| TYPE | YEAR | PROJECT NO. | SHEET NO. |
|---|---|---|---|
| R.O.W. | 2015 | HSIP-106(33) | 10A |

# EROSION PREVENTION AND SEDIMENT CONTROL PLAN

STA. 104+43 TO STA. 117+00

## STAGE 2 - INTERMEDIATE CONST.

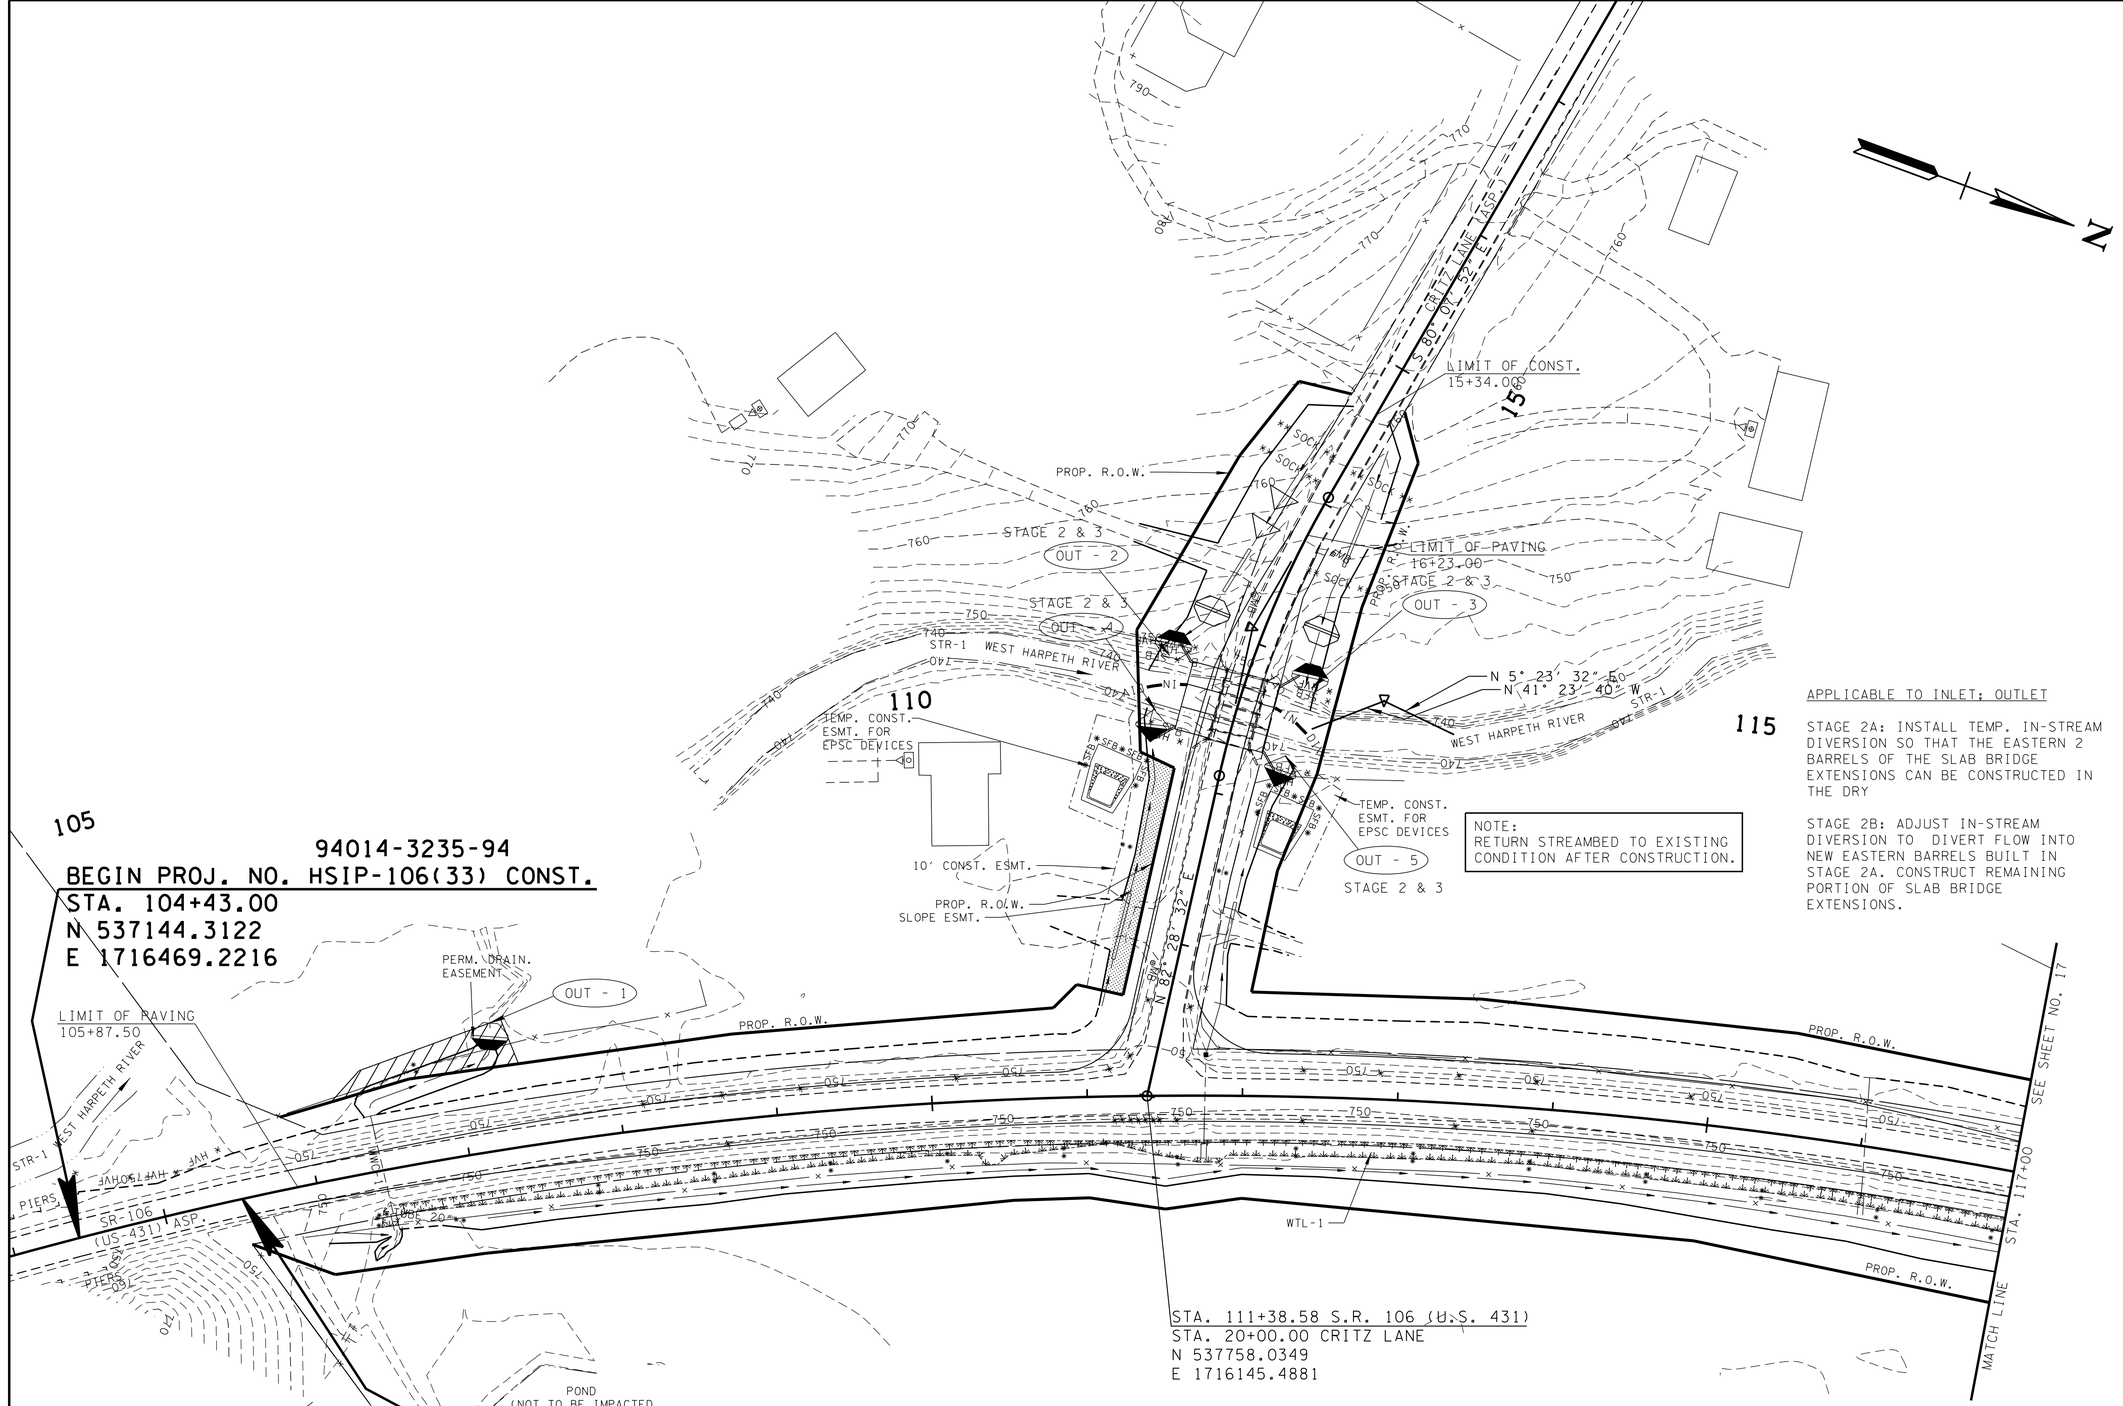
REV. 9-22-16: ADJUSTED PROPOSED R.O.W. AND TEMP. CONST. ESMT. FOR EPSC DEVICES AND ADDED SLOPE AND 10' CONST. ESMT. ALONG CRITZ LANE FOR TRACT 1. MOVED 20' BUS. ENT. FROM STA. 18+82 TO 18+97 RT. ADJUSTED PROPOSED V-DT RT. CRITZ LANE STA. 18+00 TO 19+50.

REV. 12-08-16: ADJUSTED PROPOSED R.O.W., TOE OF SLOPES, AND EPSC DEVICES ALONG S.R. 106 FROM STA. 106+00 TO 117+00 RT.

REV. 02-20-17: ADJUSTED DITCHES, SIDE DRAIN, AND PRIVATE DRIVE WIDTH LEFT STA. 16+04.
